Agentic Infrastructure

Batch Workshop #6 Speed to Power

March 2026

Only 1 Extra Step for ESRs, ELCC*

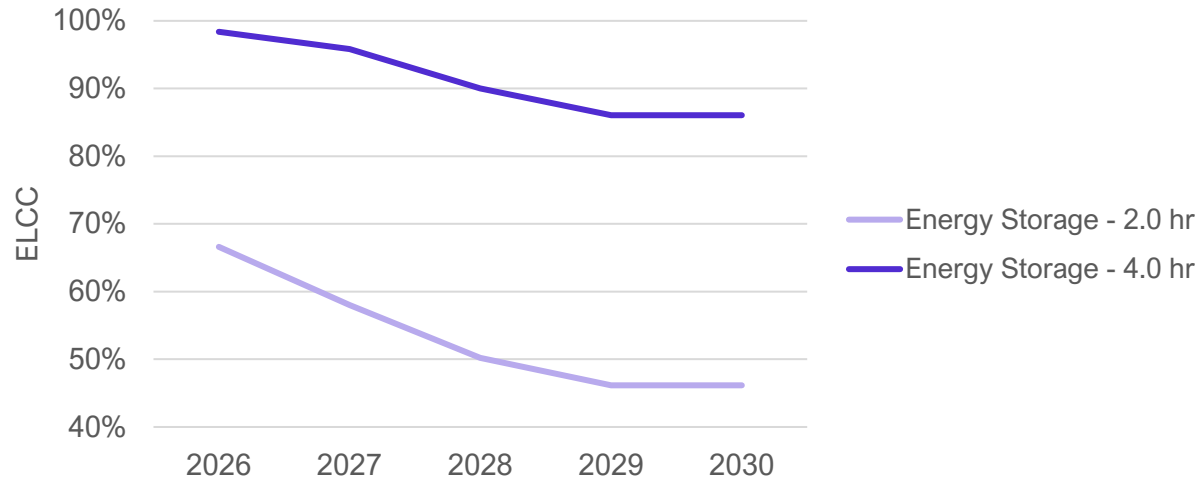
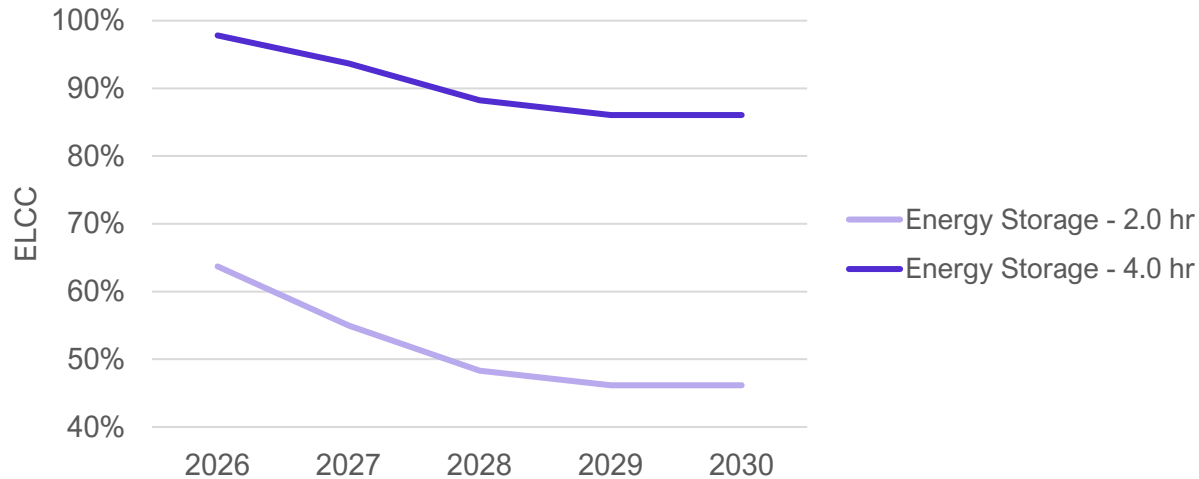
ERCOT uses this concept to inform how ESR capacity is reflected in steady state cases today and uses the figures as provided in the latest Capacity, Demand, Reserves report

1. Load granted firm service equal to $G-1 \times ELCC$ for COD year
2. Annual RTP/RPG/LCP manages delivery of firm transmission service over time as all ESR ELCCs decline (status quo tx planning today)
3. All the same caveats stated in PUN+ slide apply, resolving any operational reliability edge cases (outage schedule, local load shed, etc)**

Existing Planning Treatment for ESRs

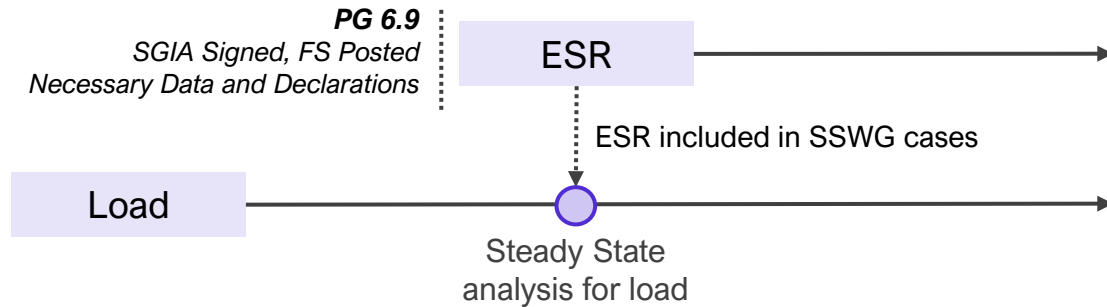
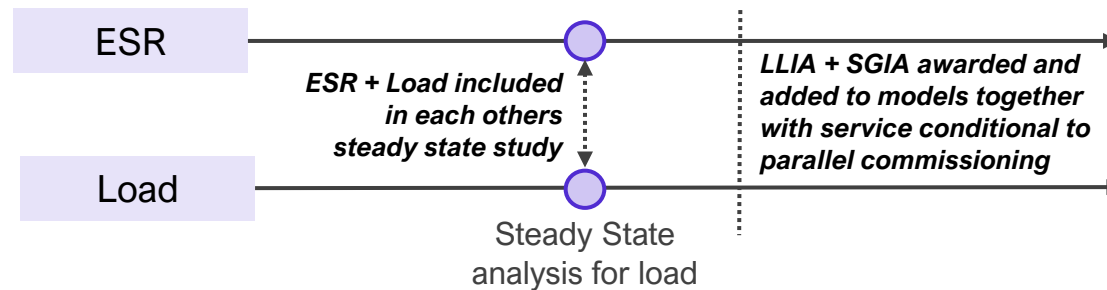
To not include ESRs in PUN+ would be extremely discriminatory market rules

leaves co-located Load + ESRs worse off than all stand-alone, unaffiliated load and ESRs operating today (aside from PG6.9 timing mismatch)

RECAP* BYOG Scenario 1: No SLF Needed

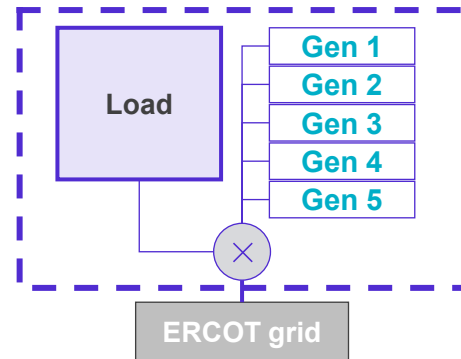
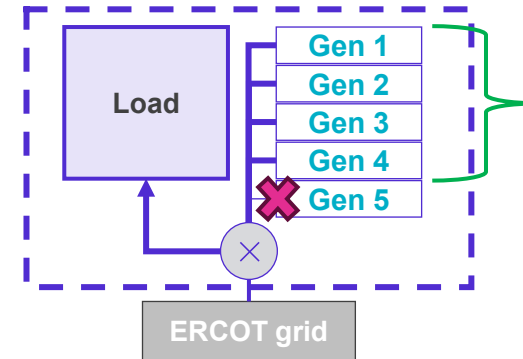
- This is how the gen and load would be treated on a stand-alone basis assuming the gen and load were both in the same steady state model
- This site design satisfies the G-1, N-1 criteria in ERCOT planning standards and therefore the site could be served **without an SLF concept**
- Only incremental rule change required would be to allow election of combining FIS/LLIS so they are studied in the same steady state study

Conceptual Planning/Interconnection Timelines

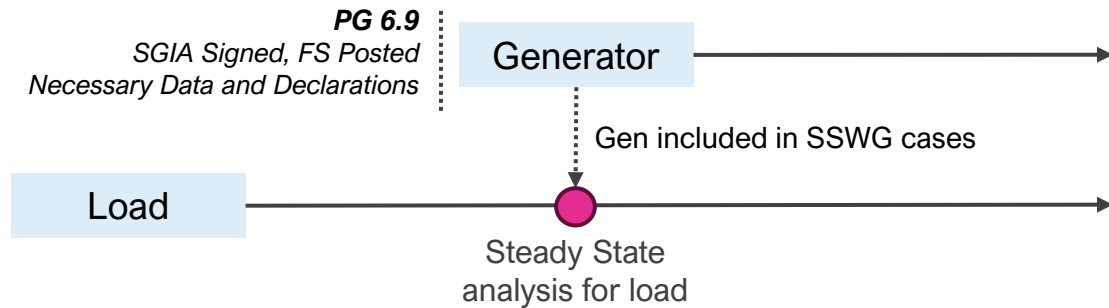
Scenario 1 as described is already how unaffiliated gen and load is treated under traditional IX today, but... **this assumes the generator had satisfied PG 6.9 which creates a process timing mismatch**

Only a minor revision to FIS/LLIS procedure should enable this scenario
